**Proposed Residential Development,
(Northern Site), Glenamuck
Kilternan, Dublin 18**

Stage 1 Quality Audit Report

Document Ref:	P25217-PMCE-XX-XX-RP-QA-3_0001				
---------------	---------------------------------------	--	--	--	--

Stage 1 Road Safety Audit

A.1.1 Junction of Street 2 and 3

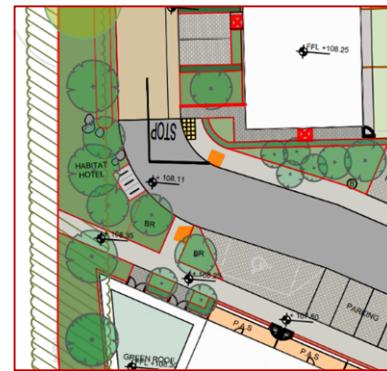
The proposed intersection of Street 2 and Street 3 in the west of the development consists of a bend in the horizontal alignment of the road with cyclist facilities, pedestrian facilities and on-street parking close to the intersection. The proposed layout at this location could result in difficulties for non-motorised road users (NMUs) in independently navigating the proposed road layout as a result of:

- A refuge (Safe Zone) area, within the proposed Home Zone area, has been indicated along the eastern side of Street 3 and does not connect directly to the footpath on the northern side of Street 2, with the tactile paving at the transition indicated as being offset from the Home Zone area.

Visually impaired pedestrians travelling on the footpath on the northern side of Street 2 would be required to travel within the carriageway before reaching the refuge area.

- A 'Stop' control junction is proposed at the bend immediately adjacent to the transition area between the footpath on the northern side of Street 2 and the Home Zone on Street 3. This may cause a pedestrian who wishes to leave the Home Zone, or the footpath, being impeded by a stationary vehicle at the Stop line.

The proposed layout of the intersection between Street 2 & Street 3 should be amended to ensure adequate inter-visibility at pedestrian crossing locations and safe routes for NMUs travelling between the footpath & refuge areas, and to/from the bicycle parking area.

The proposed Stop control at the bend should be omitted.

A.1.2 NMU Link to Glenamuck Link Distributor Road

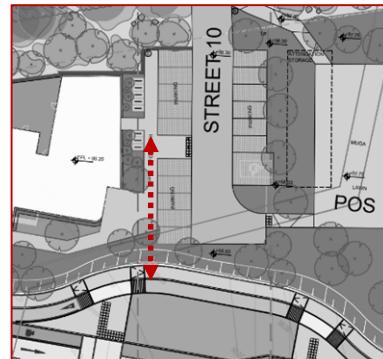
A link has been indicated between Blocks B and C to/from a proposed new toucan crossing of the Glenamuck Link Distributor Road. It is unclear if this link is intended to be used by both pedestrians and cyclists, however it is likely that both types of NMUs would seek to use this route.

If the route is not wide enough to accommodate both pedestrians and cyclists, pedestrians may use the adjacent verge for travelling.

If this link is intended to be used by pedestrians only, the absence of warning tactile paving at the transition between the footpath and the shared surface on the northern side of the Glenamuck Link Distributor Road could lead to visually impaired pedestrians being insufficiently advised that they are entering an area shared with cyclists.

The link between Blocks B and C should be wide enough to accommodate both cyclists and pedestrians, with the necessary tactile paving provided at transitions between different surfaces on this route.

A.1.4 Connectivity between Home Zone and Footpath

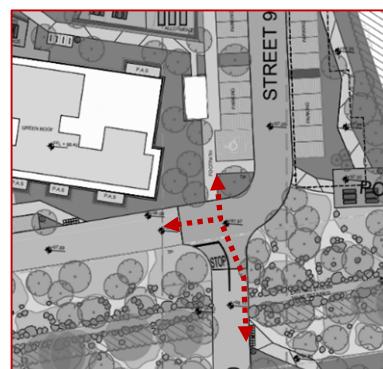
The footpath on the western side of Street 9, the Home Zone on Street 2 and the Home Zone on Street 10 are indicated terminating at the carriageway. No measures have been indicated to facilitate pedestrians, particularly visually impaired pedestrians, navigating between the Home Zones, or between the footpath and the Home Zones at this intersection. This could result in pedestrians travelling within the carriageway at the junction.

Measures should be provided to facilitate pedestrians, including visually/mobility impaired pedestrians, travelling between the Home Zones, or between a Home Zone and the adjacent footpaths, at this intersection.

A.1.5 Connectivity between Refuge Area and Footpath

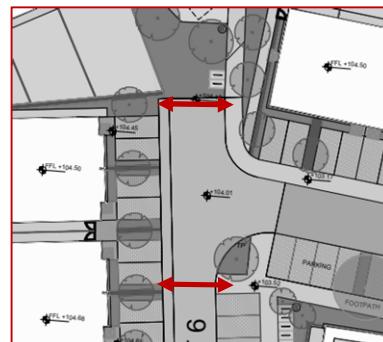
Street 6 is proposed to include a Home Zone along its length with a footpath or refuge area on either side. No connectivity has been indicated between the refuge area and the footpaths on either side of the street. Visually impaired pedestrians would have difficulties in independently navigating the proposed road layout.

Measures should be provided to facilitate visually impaired pedestrians travelling between the safe zone and the footpath on either side of Street 6.

A.1.6 Home Zone Safe Zone

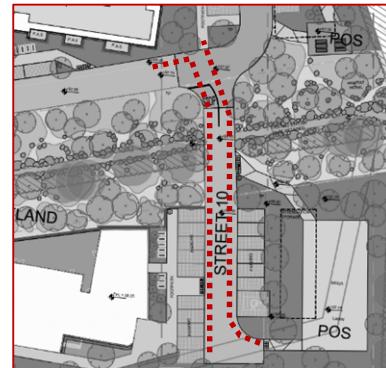
No refuge area/Safe Zone has been indicated within the Home Zone on Street 10. It is, therefore, unclear, how visually impaired pedestrians would navigate Street 10 and transition to the adjacent footpath, or refuge, as they may be insufficiently aware that they would have to share the Home Zone with motorised vehicles and cyclists.

A Safe Zone (refuge area) should be provided within Street 10 in accordance with the guidance provided by the National Disability Authority, and this should be connected to the footpaths or refuge areas on the adjacent roads.

A.1.7 Pedestrian Desire Lines

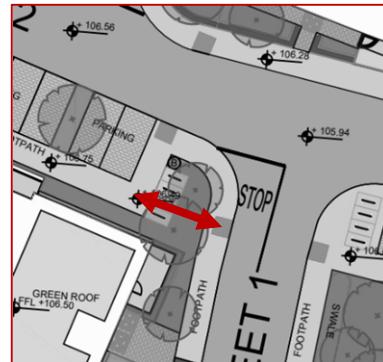
No crossing facilities have been indicated at a number of likely pedestrian crossing desire lines within the proposed development, including between residential units & the open space areas and across side residential streets.

The absence of appropriate measures at these likely crossing locations, for example dropped kerbs to facilitate the mobility-impaired and associated tactile paving to advise the visually-impaired, may lead to difficulties for the mobility impaired, particularly wheelchair users, when crossing the carriageway, or to them travelling within the carriageway to find a location where they can access the footpath.

Dropped kerbs and associated tactile paving, of an appropriate type and depth for the type of crossing, should be provided at likely pedestrian crossing locations.

Adequate inter-visibility should be available between a NMU about to commence a crossing and approaching drivers/cyclists at all proposed crossings.

A.1.9 Access to Mobility Impaired Parking Spaces

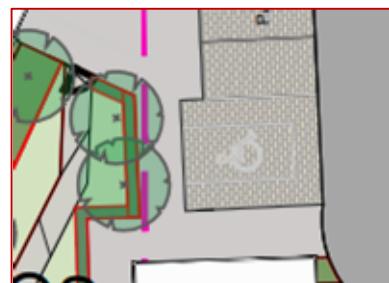
Mobility impaired parking spaces have been indicated adjacent to footpaths within the development, however no dropped kerbs and associated tactile paving have been indicated to facilitate mobility-impaired vehicle occupants travelling between the parking spaces and the adjacent footways, which could result in these road users travelling within the adjacent carriageway when seeking to access/leave the footpath.

Dropped kerbs, and appropriate tactile paving, should be provided adjacent to the proposed accessible parking spaces.

A.1.10 Delineator to Refuge

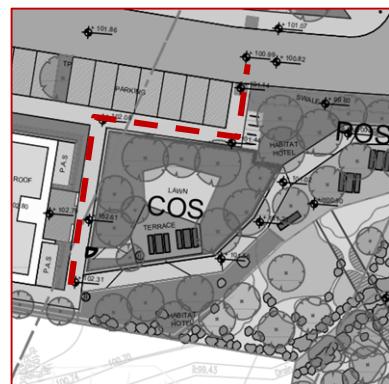
A 1.2m wide refuge area has been indicated within some of the proposed Home Zones. It is unclear, however, if a detectable (e.g. tactile) delineator kerb will be provided between the refuge area and the remainder of the Home Zone to assist visually impaired non-motorised road users.

The absence of a suitable delineator kerb could lead to difficulties for visually impaired pedestrians in independently navigating the proposed Home Zones.

The Safe Zone (e.g. refuge area) should be adequately delineated from the remainder of the Home Zone and tie-in with the footpaths outside of the Home Zone.

B.1.2 NMU Link to Glenamuck Link Distributor Road

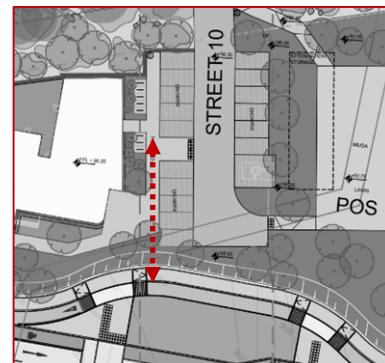
A link has been indicated between Blocks B and C to/from a proposed new toucan crossing of the Glenamuck Link Distributor Road. It is unclear if this link is intended to be used by both pedestrians and cyclists, however it is likely that both types of NMUs would seek to use this route.

If the route is not wide enough to accommodate both pedestrians and cyclists, pedestrians may use the adjacent verge for travelling.

If this link is intended to be used by pedestrians only, the absence of warning tactile paving at the transition between the footpath and the shared surface on the northern side of the Glenamuck Link Distributor Road could lead to visually impaired pedestrians being insufficiently advised that they are entering an area shared with cyclists.

The link between Blocks B and C should be wide enough to accommodate both cyclists and pedestrians, with the necessary tactile paving provided at transitions between different surfaces on this route.

B.1.4 Connectivity between Home Zone and Footpath

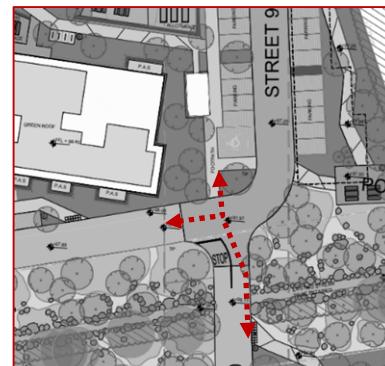
The footpath on the western side of Street 9, the Home Zone on Street 2 and the Home Zone on Street 10 are indicated terminating at the carriageway. No measures have been indicated to facilitate pedestrians, particularly visually impaired pedestrians, navigating between the Home Zones, or between the footpath and the Home Zones at this intersection. This could result in pedestrians travelling within the carriageway at the junction.

Measures should be provided to facilitate pedestrians travelling between the Home Zones, or between a Home Zone and the adjacent footpaths, at this intersection

B.1.5 Parking Spaces Adjacent to Grassed Areas

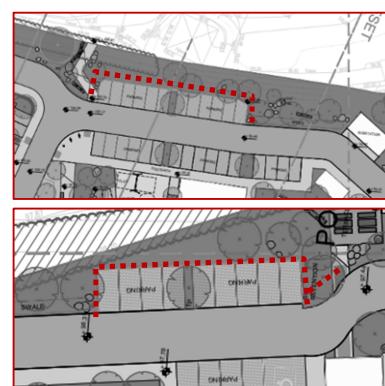
A number of on-street parking spaces have been indicated on the northern side of Street 9 adjacent to its junction with Street 8, and on the eastern side of Street 9 adjacent to apartment block C. No path has been indicated adjacent to these parking spaces which could lead to vehicle occupants traversing the grassed areas when exiting/entering their vehicles.

A path should be provided bounding these parking spaces with connections to the adjacent footpaths, or pedestrian crossing, as appropriate.

B.1.6 Access to Landscaped Areas

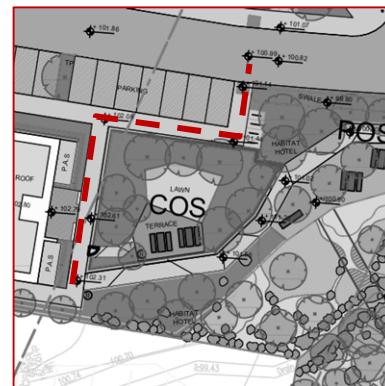
The proposed access to the Landscaped Area between Duplex C and Creche requires pedestrians to take a circuitous route on the footpath when travelling to/from the Landscaped Area. This may encourage pedestrians to traverse the grassed area for a shorter route.

A direct paved path should be provided between the footpath on the southern side of Street 2 and the Landscaped Area.

B.1.7 Access to MUGA

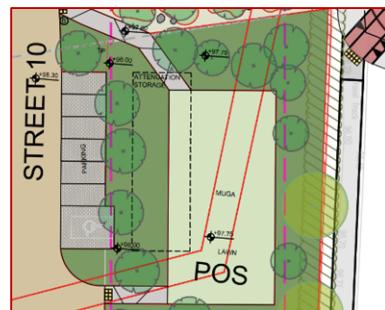
The on-street parking spaces to the west of the Multi-Use Games Area (MUGA) will likely attract vehicle occupants traversing the verge between the parking spaces and the games area.

A path should be provided along the likely desire line between the MUGA and the parking spaces.

C.1.4 Long-stay Bicycle Parking Area Doors

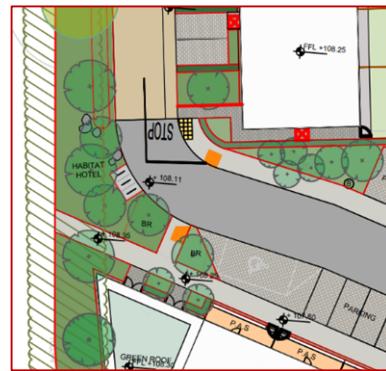
It is unclear from the information provided whether the doors to/from the bicycle store are manually operated or powered. Manually operated doors may present difficulties for cyclists accessing/egressing the store.

Doors used by cyclists should be operated electronically by automatic detection or with the push button 3m from the door.

C.1.6 NMU Link to Glenamuck Link Distributor Road

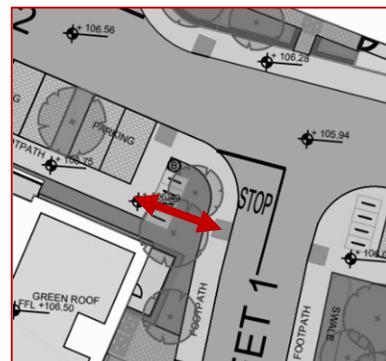
A link has been indicated between Blocks B and C to/from a proposed new toucan crossing of the Glenamuck Link Distributor Road. It is unclear if this link is intended to be used by both pedestrians and cyclists, however it is likely that both types of NMUs would seek to use this route.

If the route is not wide enough to accommodate both pedestrians and cyclists, this could result in difficulties for cyclists when travelling.

The link between Blocks B and C should be wide enough to accommodate both cyclists and pedestrians.

C.1.7 Likely Cyclist Desire Line

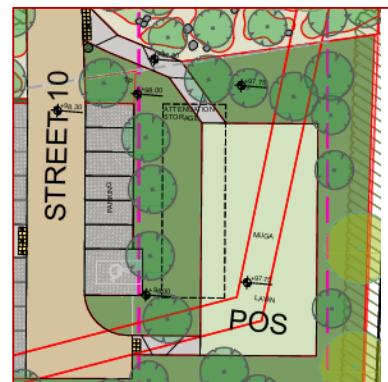
A number of bike stands have been indicated adjacent to the development access in the verge between the footpath on the southern side of Street 2 and the footpath on the western side of Street 1.

Cyclists who wish to access these bike stands may travel through the verge for a shorter distance when travelling to/from the development access.

A path should be provided through the verge along the likely NMU desire line.

3.1 Junction of Street 2 and Street 3

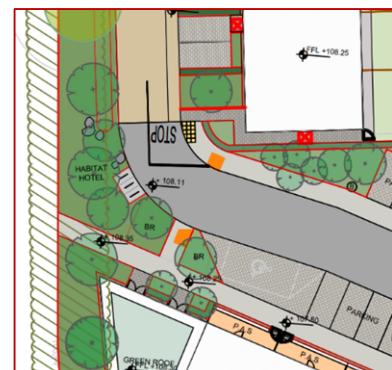
- Proposed planting on the southern side of the road, adjacent to the proposed uncontrolled pedestrian crossing, may restrict inter-visibility between westbound drivers on Street 2 and pedestrians commencing a crossing from the southern side of the uncontrolled crossing to the east of the bend in the horizontal alignment, increasing the risk of vehicle/pedestrian collisions.

- Proposed planting on the southern side of the road in the vicinity of the proposed bicycle parking may restrict inter-visibility between westbound drivers on Street 2 and cyclists exiting the bicycle parking area on the outside of the bend, which may lead to vehicle/cyclist collisions.

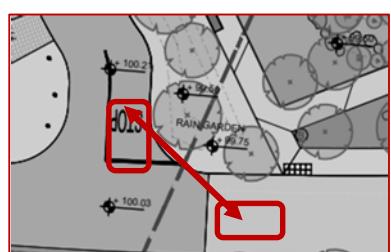
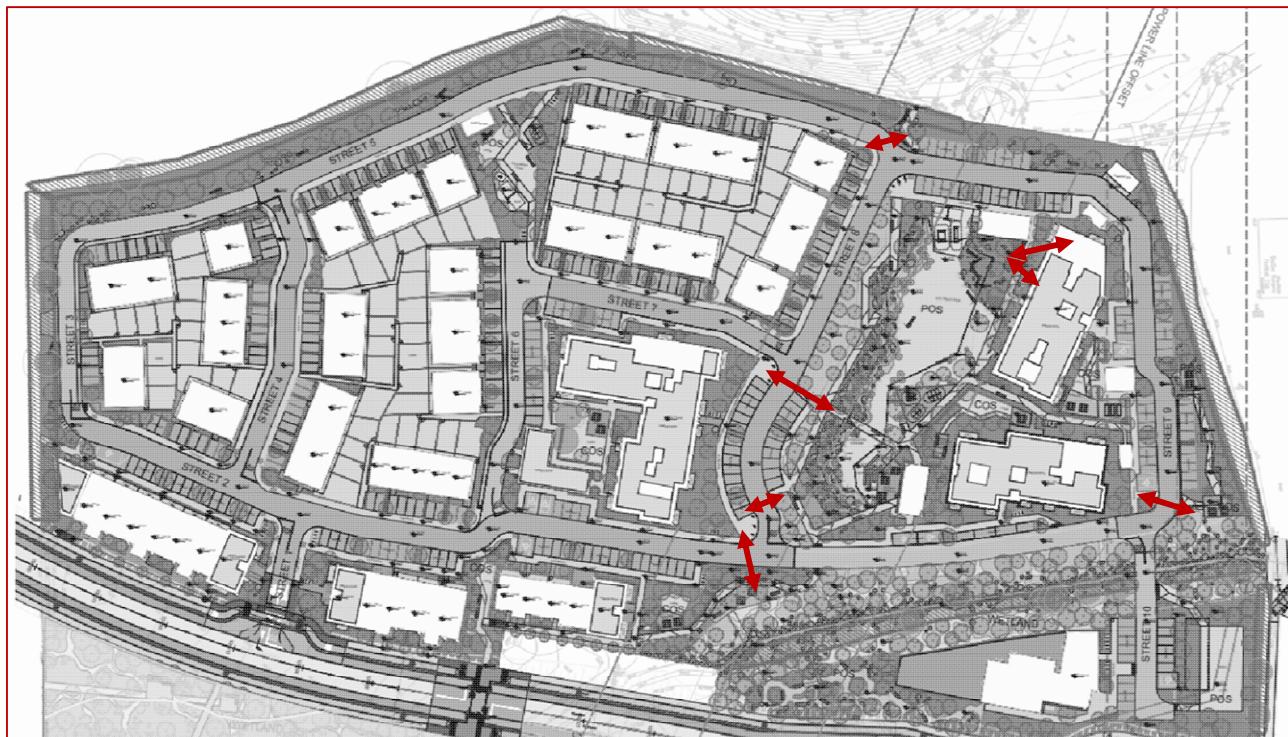
Summary: *Proposed planting, or parked vehicles, may impede inter-visibility at bends in the horizontal alignment, at transitions between Home Zones & footpaths or at pedestrian crossings.*

Planting has been indicated throughout the development. In some locations the proposed planting is indicated adjacent to pedestrian crossings and may impede inter-visibility between a pedestrian waiting at, or commencing, a crossing and an approaching driver, leading to unsafe crossings.

Proposed planting at the western end of the footpath along the southern side of the Wetland area may impede inter-visibility between a pedestrian leaving the footpath and entering the Home Zone and the driver of a vehicle reversing from the nearby parking spaces.

In addition, a number of pedestrian crossings have been indicated at locations adjacent to parking spaces. Parked vehicles may impede inter-visibility between pedestrians and approaching drivers, leading to unsafe crossings and a risk of vehicle/pedestrian collisions.

The proposed planting should not impede inter-visibility between road users within the development, in particular at pedestrian crossing locations.

Adequate inter-visibility should be provided at all crossings.

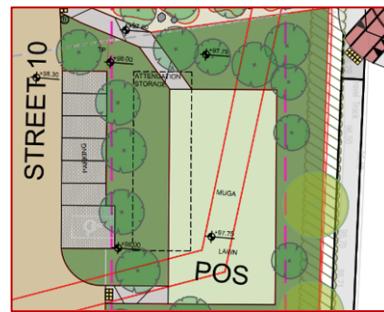
4.1 The on-street parking spaces to the west of the Multi-Use Games Area (MUGA) will likely attract vehicle occupants traversing the verge between the parking spaces and the games area, increasing the risk of slips, trips and falls.

A path should be provided along the likely desire line between the MUGA and the parking spaces.

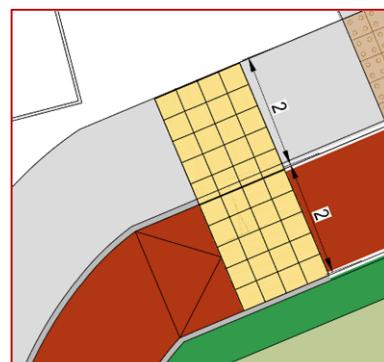
4.2 Ladder and Tramline tactile paving has been indicated on Glenamuck District Distributor Road. During the design development care should be taken to ensure that the appropriate profile for the 'corduroy' tactile paving is provided at transitions between a pedestrian-only footpath and a shared use route in accordance with the NDA Guidance "Building for Everyone" and the UK's "Guidance on the Use of Tactile Paving Surfaces" document.

The correct 'Ladder & Tramline' tactile paving, with flat-topped bars should be provided at the transitions between the shared surfaces and segregated footpath and cycle tracks within the Scheme.

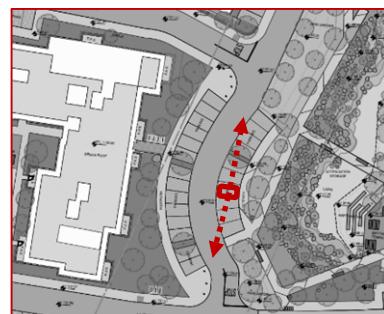
4.4 A number of on-street perpendicular parking have been indicated on both side of the curve on Street 8 adjacent to its junction with the Street 2, where drivers exiting the parking spaces on the inside of the curve may have reduced visibility towards approaching vehicles on Street 8, possibly leading to unsafe exits from the parking spaces.

'Reverse Parking Only' should be permitted within the parking spaces on the inside the curve.
